Subject: **REDUCTION OF MASTER ERASE  
SIGNAL DISTORTION**

Model: **APR-5002/5003**

Serial No: **20,001 AND HIGHER**

**Figure 1**

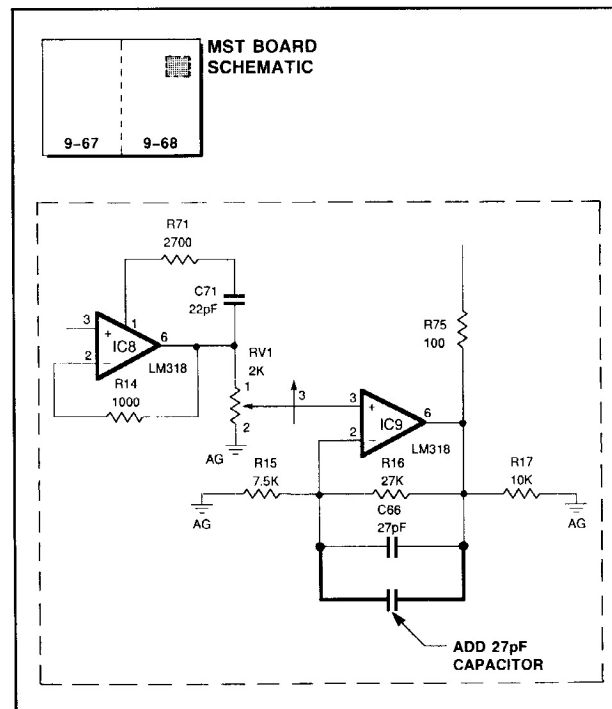
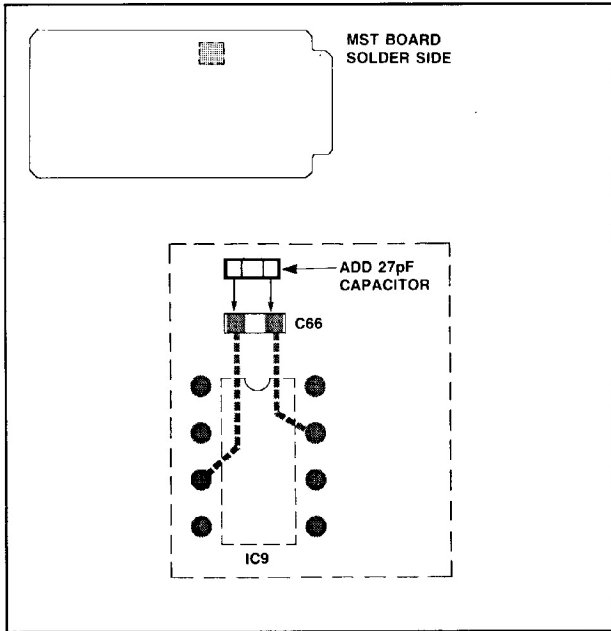
The erase transient at the end of a recorded segment may be too large in APR-5002/5003 units that contain an MST Assembly with part number A-7850-376-B or A-7850-377-B. To correct this problem, perform the modifications described in the following procedure.

**Solder Side (See Figures 1 and 2.)**

1. Verify that master bias level is 15Vpp.
2. Perform record alignments for both channels.
3. Load a bulk erased tape into recorder.
4. Remove MST Board from unit.
5. Solder a 27pF capacitor in parallel with C66.
6. Replace MST Board into unit.
7. Remove CH1 CNL Board from unit.
8. Remove heat sink plate from board.
9. Replace CNL Board on card extender.

10. Power up unit.
11. Verify that the bias level at CN-30B of CNL Board is 15 Vpp. If necessary adjust RV1 on MST Board.
12. Connect oscilloscope CH-A input to CH-1 Line Out.
13. Connect oscilloscope CH-B input and EXT trigger input to IC23-8.
14. Set oscilloscope sweep to 5ms/div and Volts/div for 50mv/div. Select NORMAL and EXT trigger source.
15. Alternately select PLAY then RECORD modes at 1 second intervals.

Figure 3

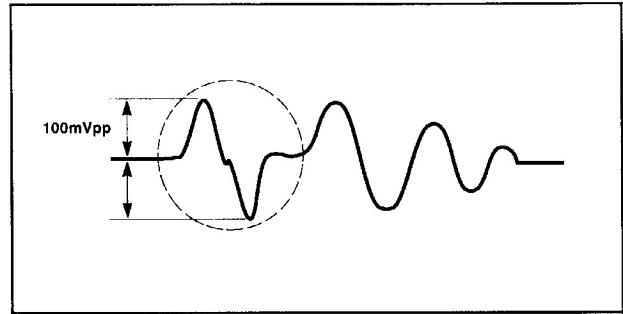
16. Adjust oscilloscope trigger level until *punch out* transient is easily detectable. See Figure 3.
17. Verify that transient is 100 mVpp or less. If specification is not met, contact your local Sony Regional Service Center.
18. Turn off power.
19. Replace heat sink on CNL Board and place board back into unit. Repeat steps 7 through 10 and 12 through 19 for CH-2 CNL Board.
